SUBJECT: Beaver Valley Power Station - Unit No. 2
Docket No. 50-412
Significant Deficiency Report 82-04
"Westinghouse Solid State Protection System"

Report on Significant Deficiency 82-04
"Westinghouse Solid State Protection System"

Subject POTENTIAL UNDETECTABLE FAILURE-ONLINE TEST SWITCH		Number NSD-TB-84-01
System(s) SOLID STATE PROTECTION SYSTEM		Date MARCH 20, 1984
Affected Plants SEE ATTACHMENT III	AFFECTS SAFETY RELATED EQUIPMENT YES <input checked="" type="checkbox"/> NO <input type="checkbox"/>	S.O.(s) 387
References SRC-ID-82-194 CHANGE CONTROL NO 6156		Sheet <u>1</u> Of <u>7</u>

SIMPLIFIED SKETCH OF TYPICAL SAFEGUARDS ACTUATION RELAY TESTING IN THE SSPS

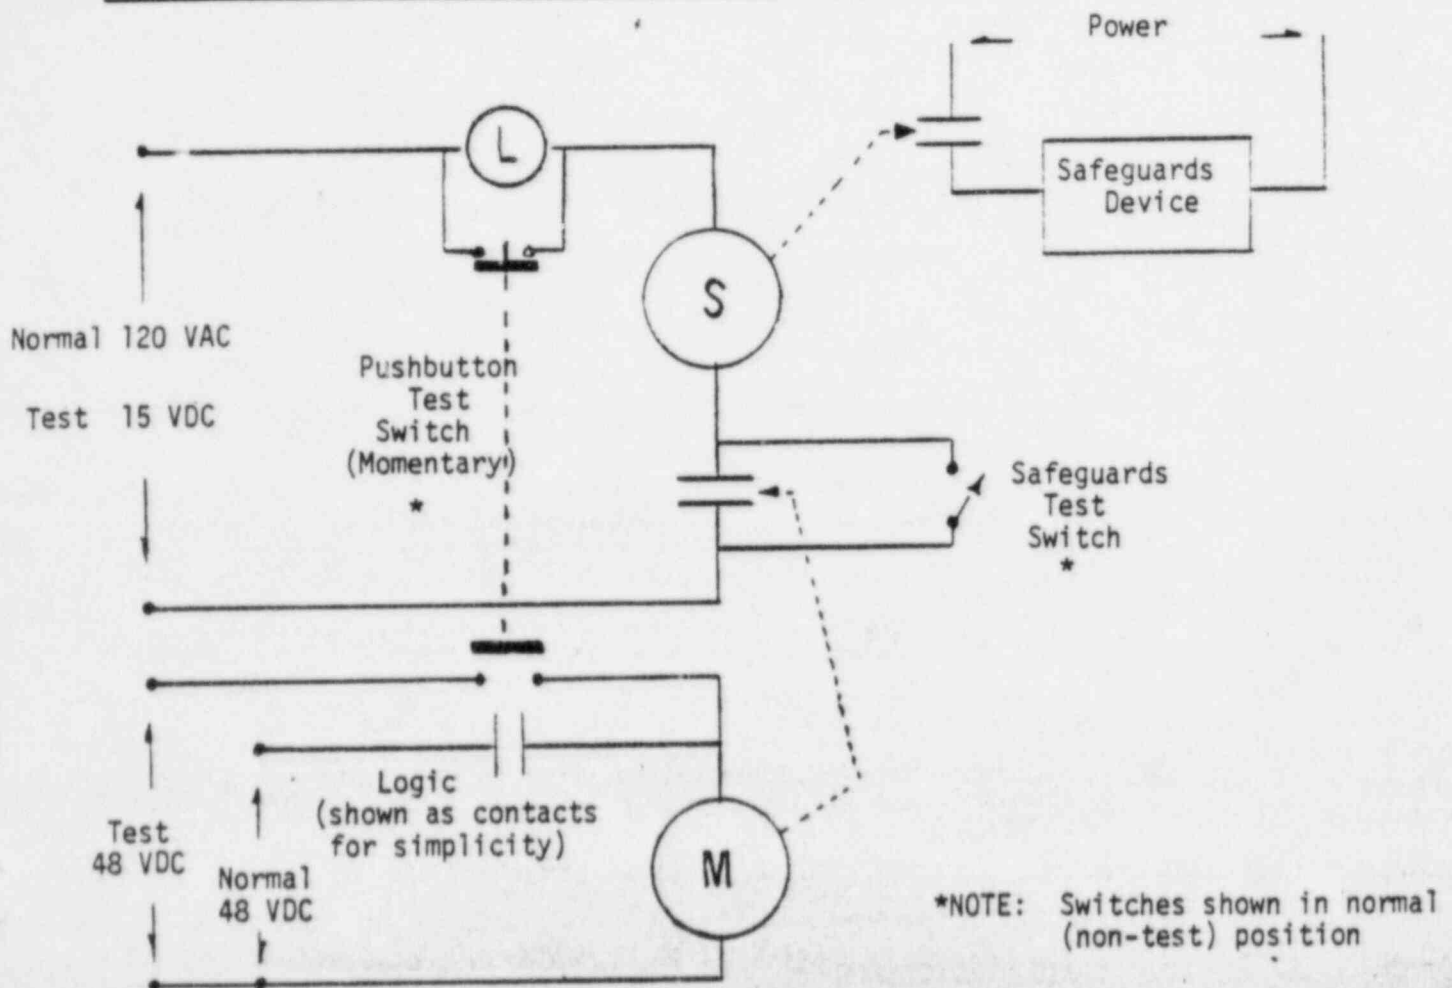
PROBLEM: If the contacts shunting the proving lamp L do not reclose when the puchbutton is released and the system is returned to normal, then 120 VAC would be applied to the Slave relay coil thru the proving lamp if Safeguards actuation were called for by the logic contacts. (Lamp may fail before relay S operates)

OUTPUT RELAY TEST CIRCUIT
STANDARD 2-TRAIN SSPS

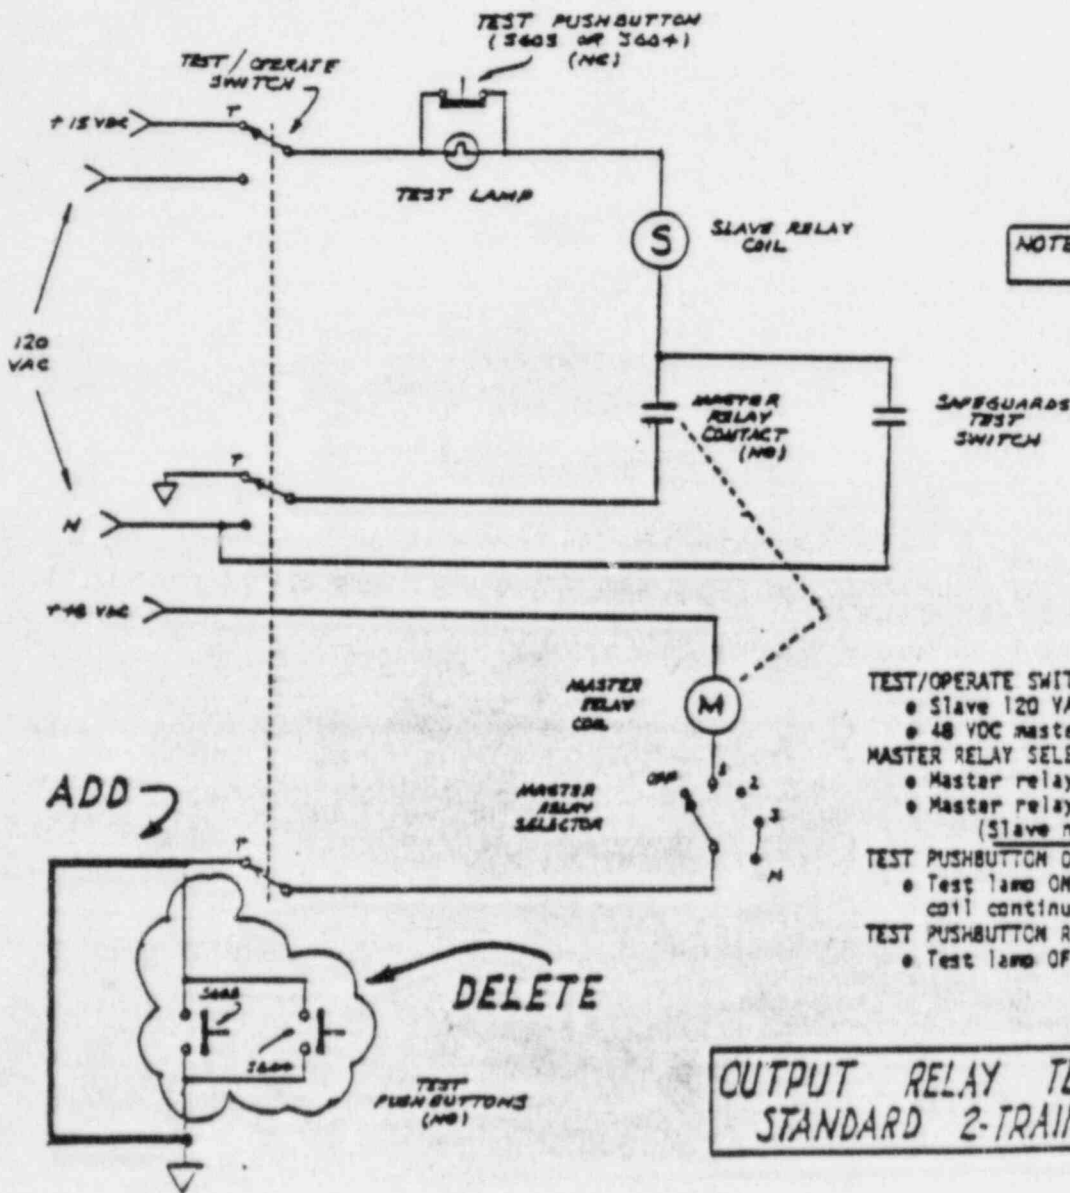
- TEST/OPERATE SWITCH TO TEST
 - Slave 120 VAC reduced to 15 VDC
 - 48 VDC master relay ground returned
- MASTER RELAY SELECTOR SWITCH TO RELAY BEING TESTED:
 - Master relay energizes
 - Master relay contacts close 15 VDC to slave (Slave not energized on 15 VDC)
- TEST PUSHBUTTON DEPRESSED
 - Test lamp ON confirms circuit and slave relay coil continuity.
- TEST PUSHBUTTON RELEASED
 - Test lamp OFF confirms test lamp shunted

That review has now been completed, and affected plants (see Attachment III) will be sent formal change recommendations for a relatively minor circuit modification which will obviate the need for the special testing. Conceptual descriptions of the changes are shown in Attachment IV, and detailed change recommendations will be sent as soon as they are completed.

OUTPUT RELAY TEST CIRCUIT EXPANDED 2-TRAIN SSPS

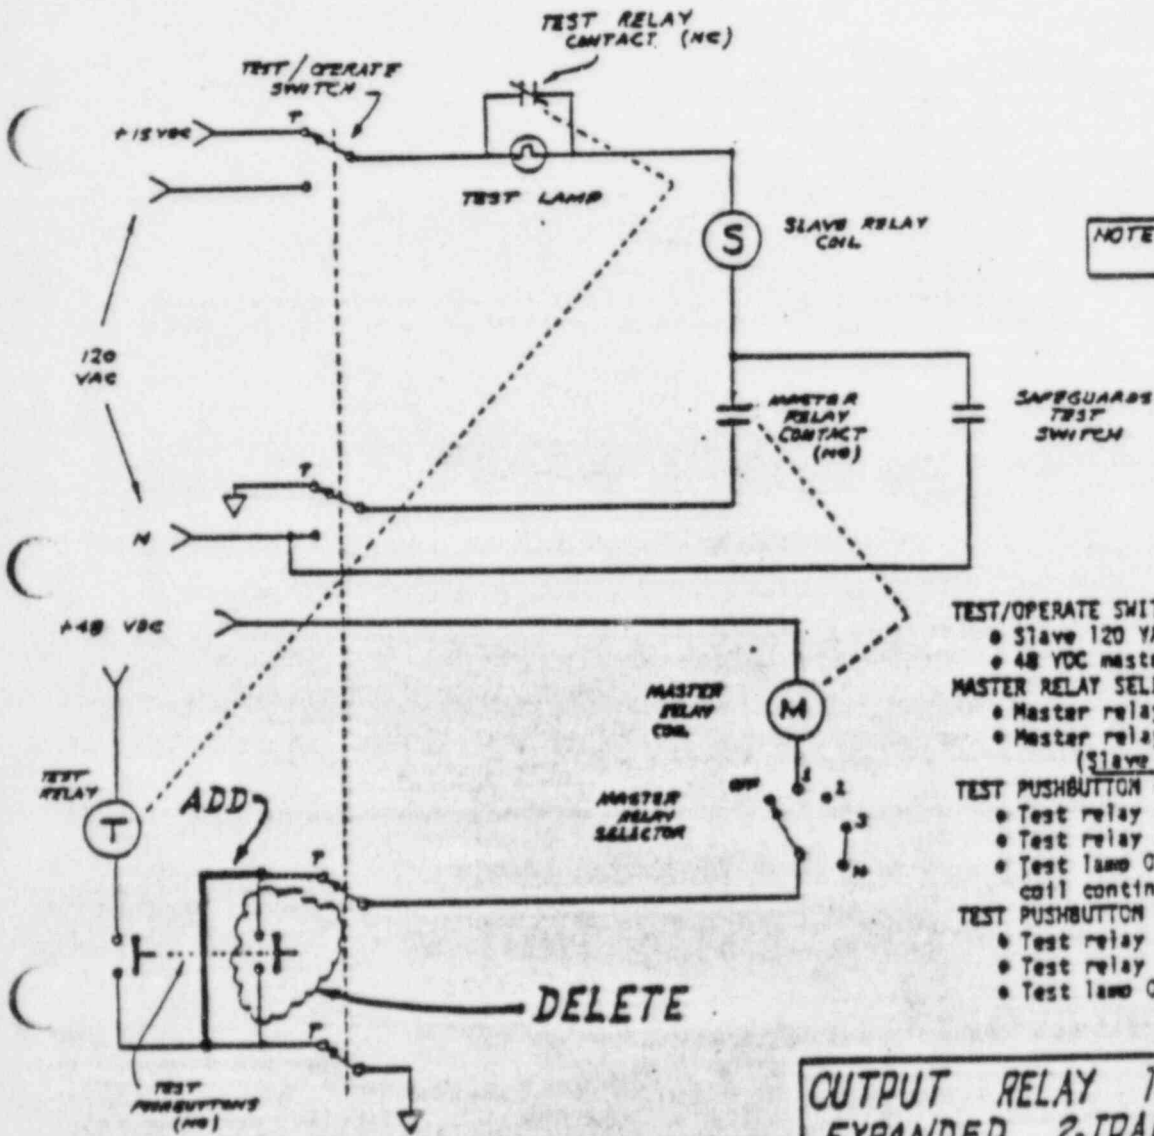
- TEST/OPERATE SWITCH TO TEST
- Slave 120 VAC reduced to 15 VDC
 - 48 VDC master & slave relays ground returner
- MASTER RELAY SELECTOR SWITCH TO RELAY BEING TEST:
- Master relay energizes
 - Master relay contacts close 15 VDC to slave (Slave not energized on 15 VDC)
- TEST PUSHBUTTON DEPRESSED
- Test relay energizes
 - Test relay contacts open
 - Test lamp ON confirms circuit and slave rel coil continuity
- TEST PUSHBUTTON RELEASED
- Test relay de-energized
 - Test relay contacts close
 - Test lamp OFF confirms test lamp shunted
